Site Technical Query - Form

TQ Number:		Project:	
CW2144960	-A010- 0052	Oyu Tolgoi Underground Project	
A. To be completed by or on behalf of the Contractor			
Contractor/Sub-Contractor Name:	MCS International	Date Response	21/01/2022
Contract Title:	Booster Fan installations	Plant Area &	1833
Contract No.	CW2144960	Contractor TQ Number:	BF-0415-TQ-0052
Discipline Codes (Mandatory) D1 (CSA) - <input type="checkbox"/> D2 (MP) - <input checked="" type="checkbox"/> D3 (E&I) - <input type="checkbox"/> D4 (Other) - <input type="checkbox"/>

Description of Technical Query (List affected drawings and specifications):
SP2, SP3 Secondary Ventilation Duct location change issue

SP2 area-Clash between the Ventilation duct and shotcrete surface

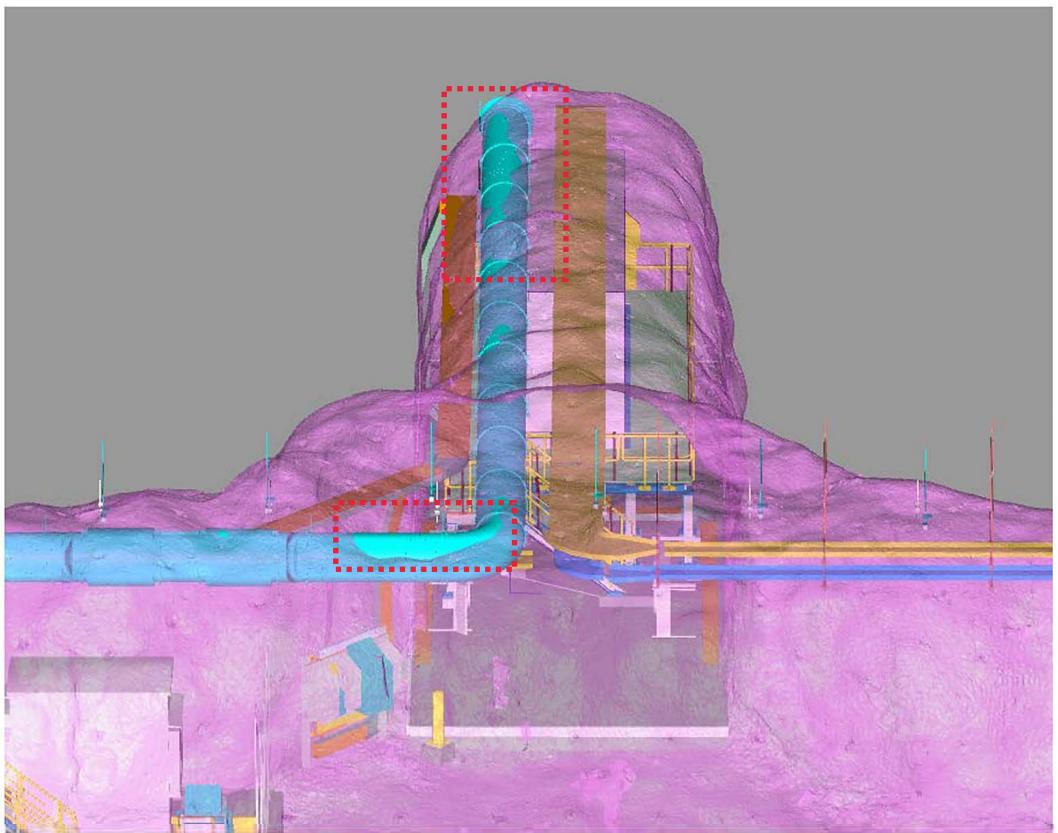
SP3 area-Clash between the Ventilation duct and shotcrete surface

Attachment 2 Distance check

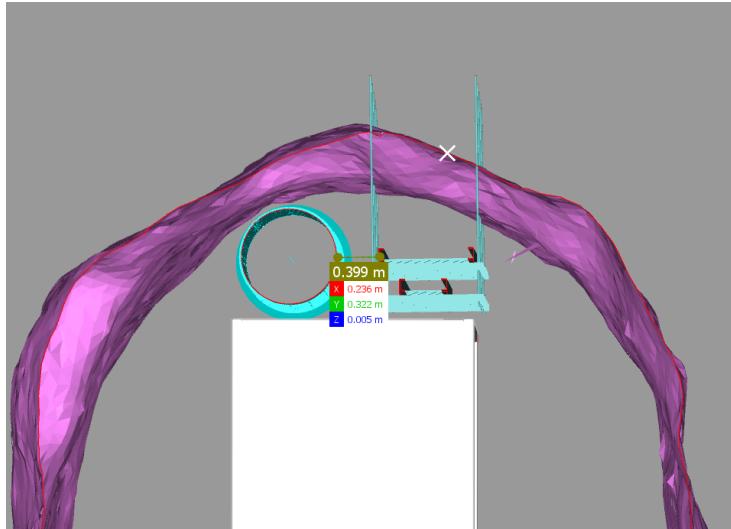
SP-3 - Proposing solution: When the cable ladder will be moved 1000 mm to wall side, the distance between cable ladder and side wall.

SP-2 : When the Duct will be moved 700 mm to the right, the distance between shotcrete surface and duct.

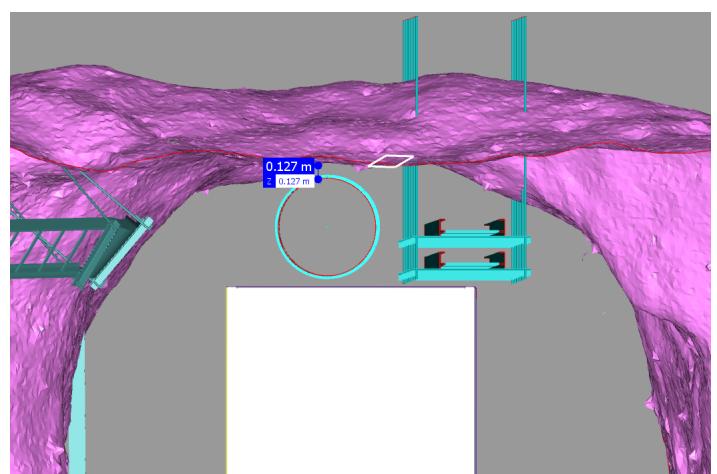
SP-3 : When the Duct will be moved 1000 mm to the right, the distance between shotcrete surface and duct.
